26<sup>th</sup> July 2023

**Re: 2023/0692/P - 13 BELSIZE CRESCENT, LONDON, NW3 5QU**

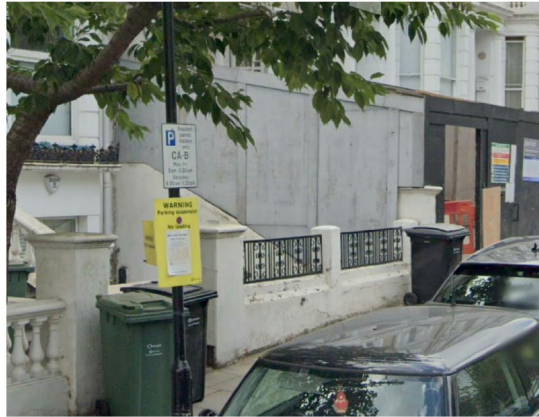
One objection also raises concern with light pollution from the skylight in the roof of the basement in the front lightwell and to the rear which the objector considers will create vertical light pollution. The front lightwell is located at lower ground floor level and is not therefore visible from the street. At the rear, natural light will arrive in the basement via light tubes, designed to minimise light pollution from

Objections suggested that a Skylight at the front is contrary to section 2.6 of the Camden Planning Guidance on basements. However, section 2.6 of the CPG on basements states that *“Where a basement extension under part of the front or rear garden is considered acceptable, the inclusion of skylights designed within the landscaping of a garden will not usually be acceptable, as illumination and light spill from a skylight can harm the appearance of a garden setting.”* The proposed skylight does not fall within the landscaping of the garden, but merely replaces existing hardscaping, at the bottom of an existing light well, and hence there is no damage to any garden setting.

the basement to the outside. Therefore, the proposed sky lights would not result in unacceptable light pollution to the detriment of neighbour amenity and visual amenity of the conservation area.
